Site Survey of Selected Items
for
Compliance with the Americans with Disabilities Act
(ADAAG)
and
Title 24 of the CBC

The site survey of 32nd Street School was conducted on
February 27, 2007 during a spot check for compliance with the
Americans with Disabilities Act Guidelines (ADAAG)
and
Title 24 of the CBC

Facility Name: 32nd Street School

Programs, Services, and Activities

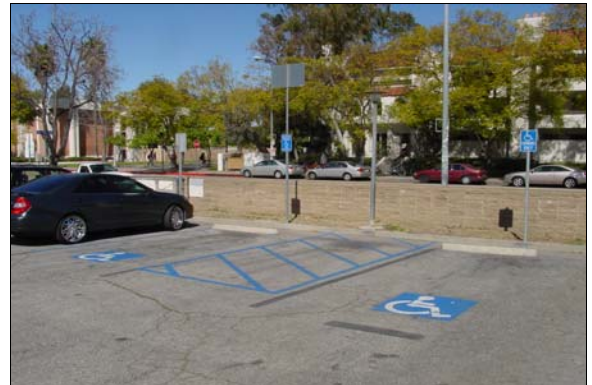
Finding: The 32nd Street School is located at 822 West 32nd Street Los Angeles California. The school provides services to students in grades K thru 8 and was inspected by Disability Access Consultants, Inc., on February 27, 2007. This is a report of selected items and is not intended as a full report.

Full Rec Any renovation or new construction that occurred after January 26, 1992, is subject to meet full code specifications for the California Building Code and ADAAG requirements. All recommendations in this report are based on ADAAG and CBC title 24 requirements. Consult with your design professional to determine which elements are affected by these requirements. It is recommended that Disability Access Consultants, Inc. is consulted for inspection of any new construction or renovation at the facility.
